**DOCUMENT 00 90 00
ADDENDUM**

ADDENDUM NO. [1] Date: February 16, 2021

**RE: WESTERN TECHNICAL COLLEGE
 SPARTA PUBLIC SAFETY EXPANSION
 11177 COUNTY HWY A
 SPARTA, WISCONSIN 54656
 HSR PROJECT NO. 20028**

FROM: HSR Associates, Inc
 100 Milwaukee Street
 La Crosse, WI 54603
 (608) 784-1830

2 MECHANICAL ROOM 2M3 & 2M4 ENLARGED REMOVAL PLAN
1/4" = 1'-0"

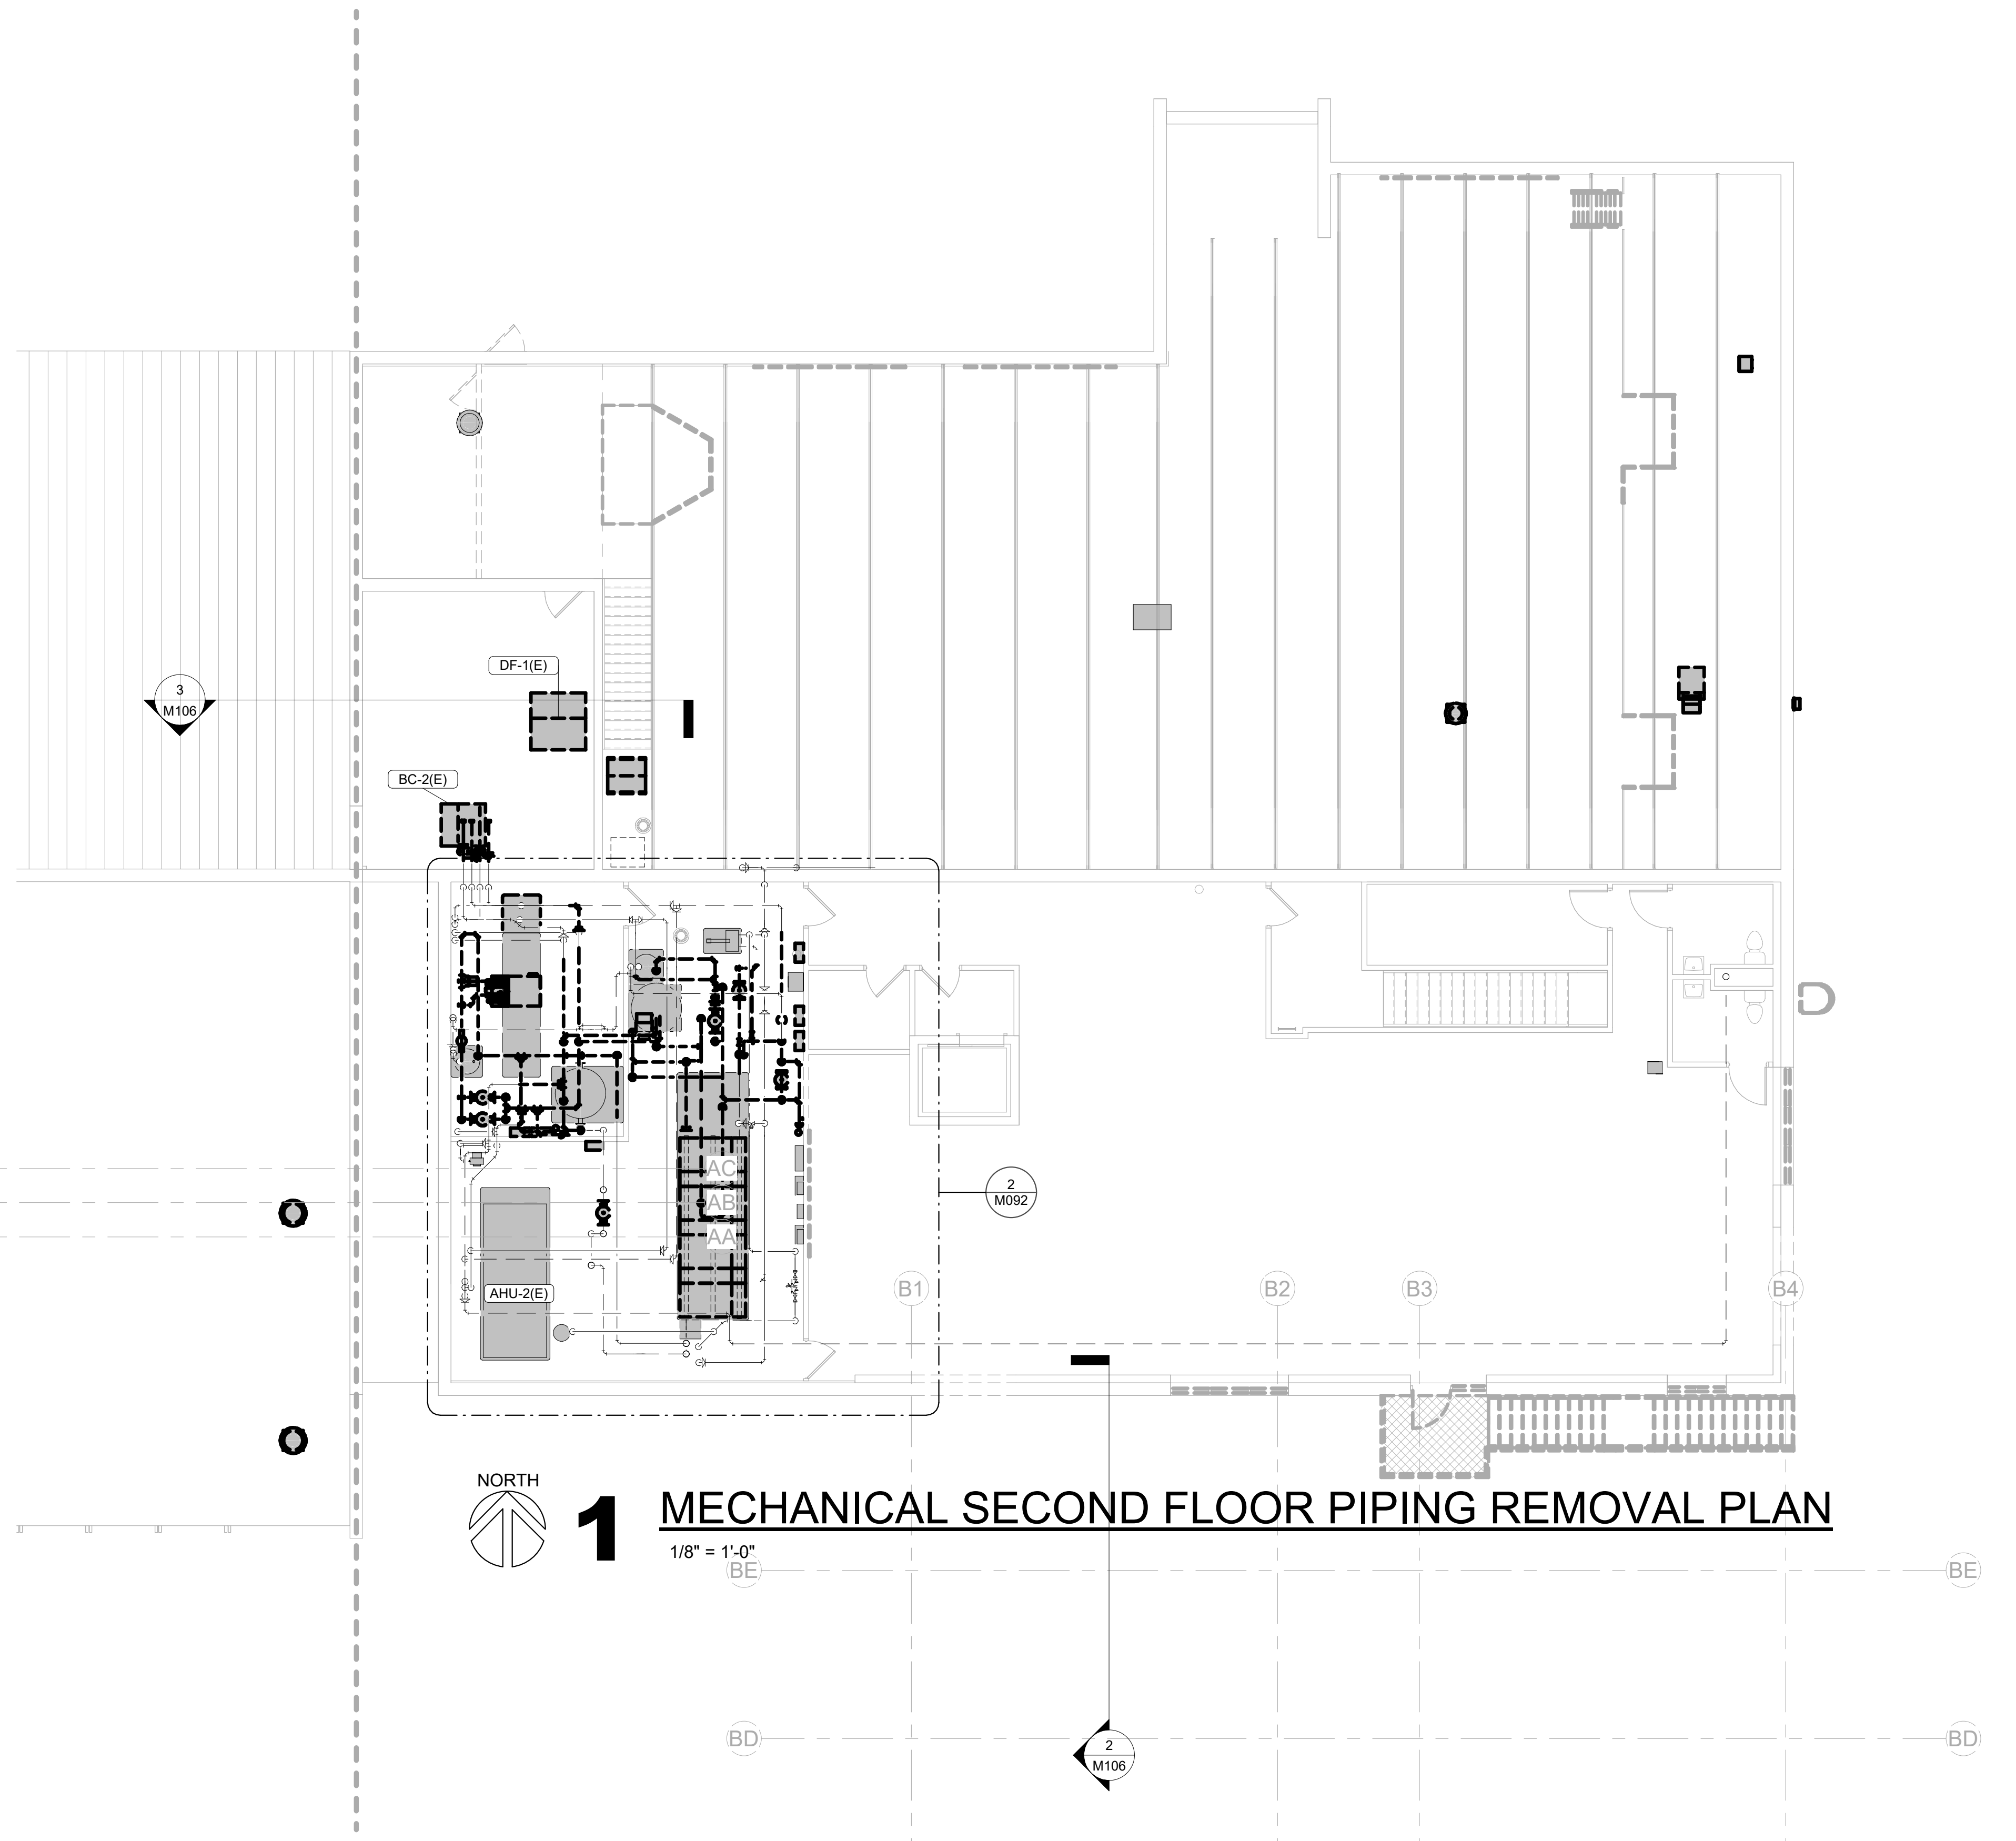
- c. Added equipment tags.
23. Sheet M092 SECOND FLOOR PIPING REMOVAL 30 x 42 attached hereto
 - a. Revisions clouded on Drawing
 - b. Added removal notes.

- c. Added Mechanical Room 2M3 & 2M4 3D View.
24. Sheet M100 FIRST FLOOR PIPING REMODEL – A 30 x 42 attached hereto
 - a. Revisions clouded on Drawing
 - b. Added room names.

1 MECHANICAL ROOM 2M3 & 2M4 ENLARGED REMODEL PLAN

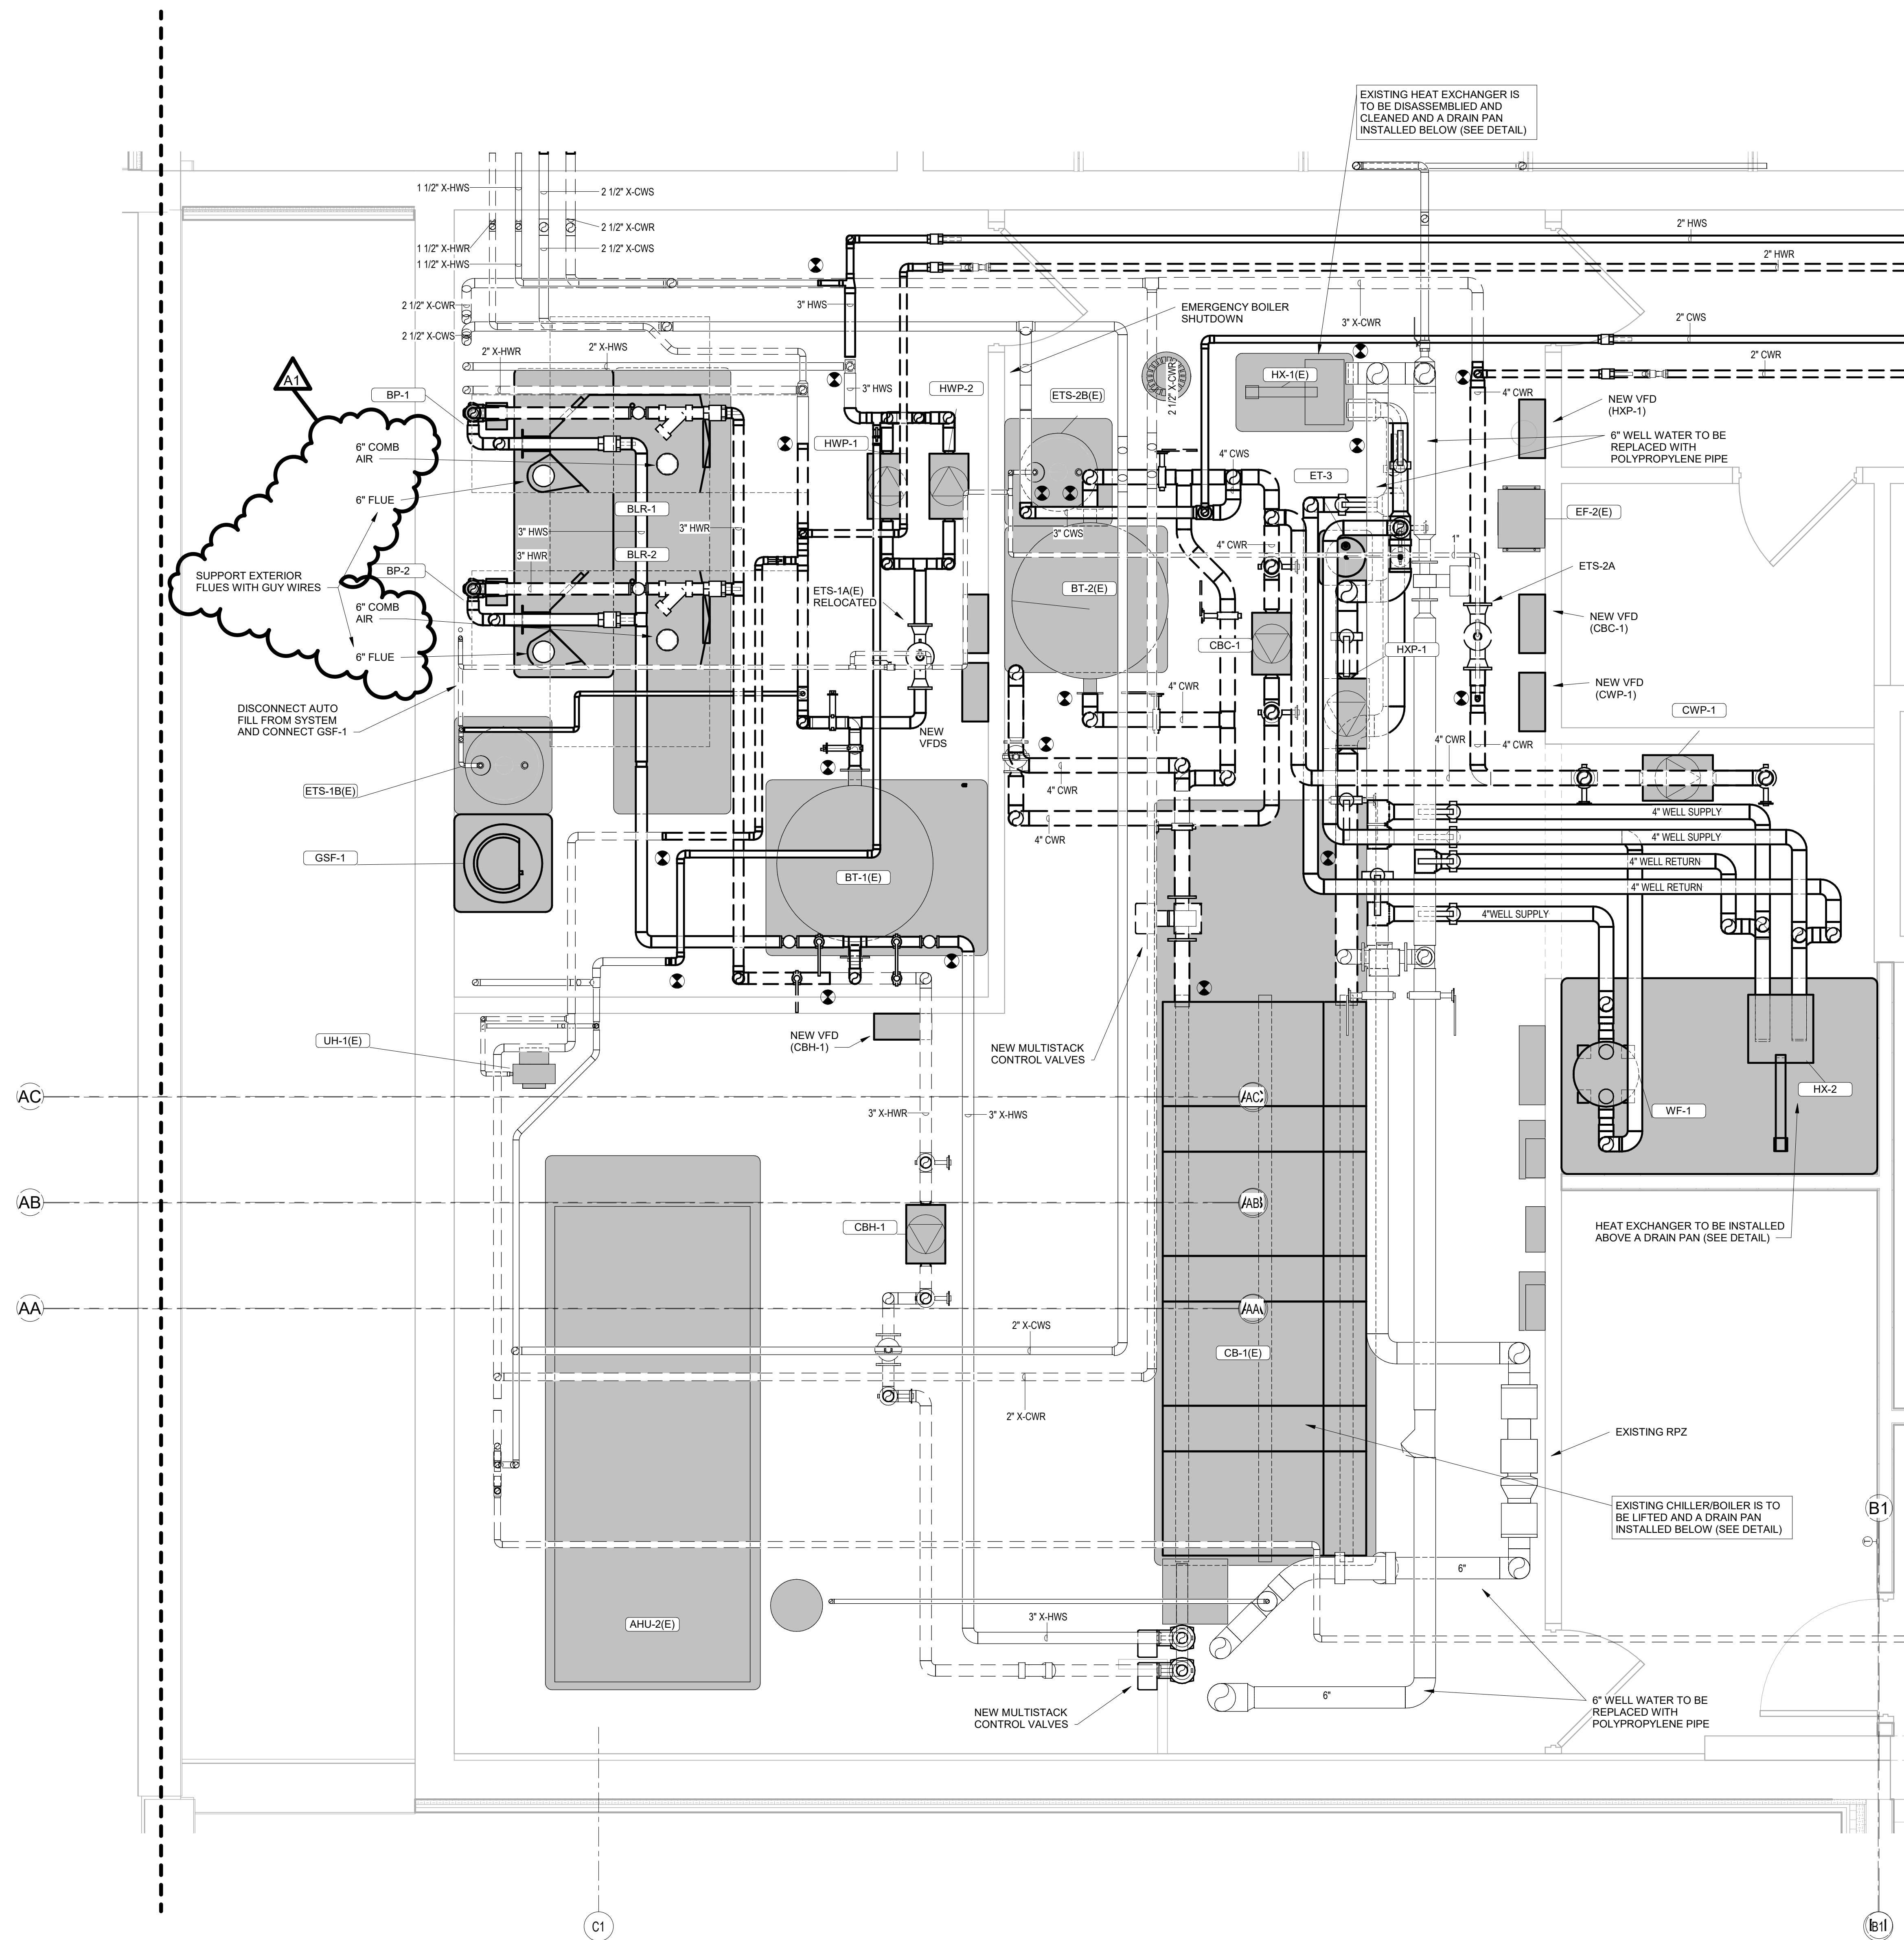
25. Sheet M103 ENLARGED MECHANICAL ROOM 2M4 30 x 42 attached hereto
 - a. Revisions clouded on Drawing
 - b. Changed boiler venting to vertical.
26. Sheet M106 SECOND FLOOR DUCTWORK REMODEL 30 x 42 attached hereto
